Capitol Hill Restoration Society P.O. Box 15264 Washington, D.C. 202.543.0425

Re: HPA 17-227 316 G Street, NE

We reviewed the plans for the project dated February 9, 2017. Thank you for letting us share our views on this project. This project raises serious preservation concerns.

Figure 4. Cornice detail, Classical Revival rowhouse, 308 G Street, NE

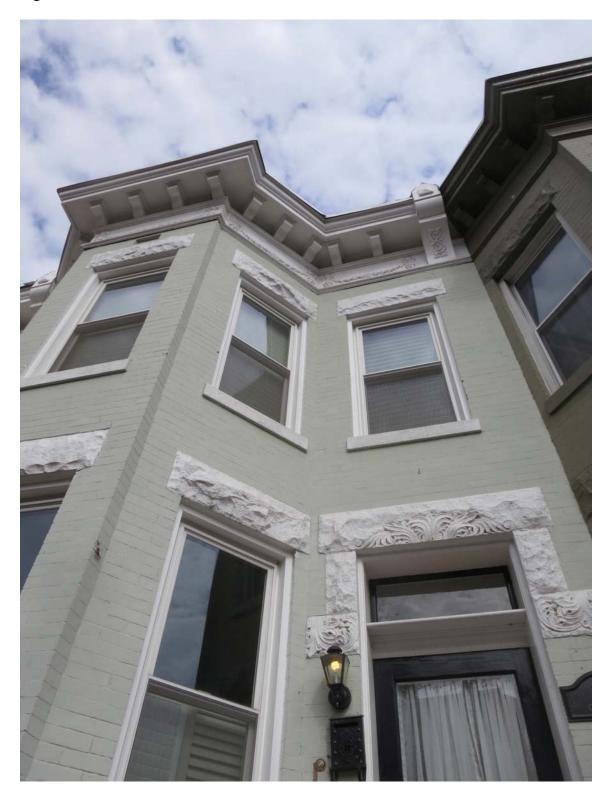
The poster photograph for the Swampoodle expansion would be the 300 block of G Street, NE, with its beautiful line of Classical Revival bayfronts. Figures 2 - 4. This block is pristine - there are no third-story additions here. The project proposes a third story rear addition which would be the only third story structure on this block. Although the sight line study indicates that the addition would not be visible from across G Street, it would be visible from oblique angles on G Street. This area of Capitol Hill is experiencing major development pressures; since Swampoodle was included in the Capitol Hill Historic District in 2015, there have already been

six HPRB cases, and additional cases can be expected. Allowing this visible third story would set a bad precedent that would soon be copied.
